**Report Type:** DA Access Report  
**Reference Number:** 20147  
**Client:** Emag Apartments  
**Site Address:** 2-18 Station Street, Marrickville, NSW

# ACCESS REPORT

This Access Compliance Report is to accompany a Development Application for the development proposed at 2-18 Station Street, Marrickville, NSW.

[Image description: Plan of Basement 1 above shows the provision of Accessible parking spaces]

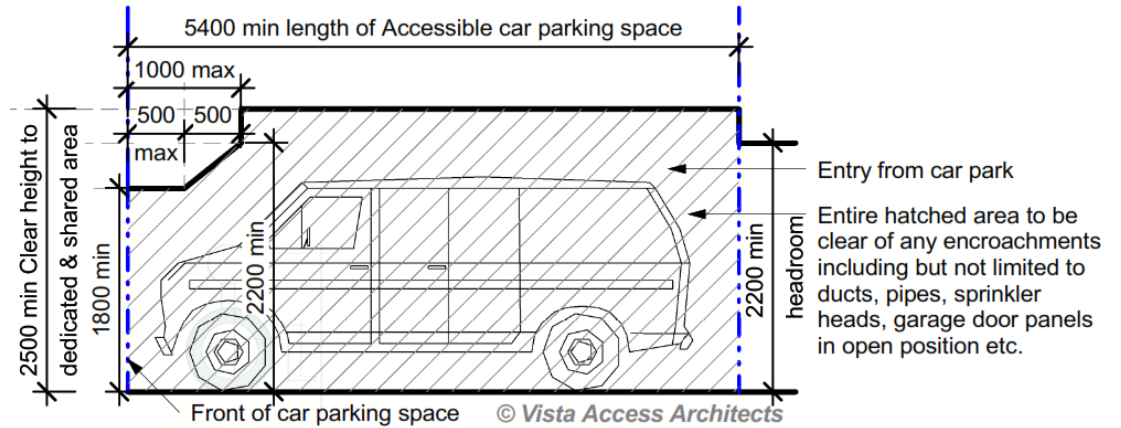
BCA Part D3.5 Accessible Carparking	
<b>Requirement</b>	<p><b>Class 3</b>            For Accessible parking requirements for boarding house, guest house, hostel etc.            Multiply total number of carparking spaces provided by the % of            - Accessible SOUs to the total number of SOUs or            - Accessible bedrooms to the total number of bedrooms            Calculated to the next whole number</p> <p>For Accessible parking requirements for residential part of school, accommodation for the aged, the disabled or children, residential part of health care building etc.            - 1 space per 100 carparking spaces</p>
<b>Compliance Comments</b>	<p>Complies.            Total number of carparking spaces provided = 45 allocated to the Residential component            Total number of accessible parking spaces required / provided as per the formula listed above in the requirements = 3            Detailed features of the accessible parking space to be verified at CC stage of works.</p>

<b>Requirement</b>	<p><b>Class 5</b>            - 1 Accessible car parking space per 100 carparking spaces</p> <p><b>Class 6</b>            - 1 Accessible car parking space per 50 carparking spaces (up to 1000 spaces) and additional 1 Accessible car parking space per additional 100 spaces provided</p>
<b>Compliance Comments</b>	<p>Complies.            Total number of Accessible parking spaces required / provided for the commercial component of the development = 1            Detailed features of the accessible parking space to be verified at CC stage of works.</p>
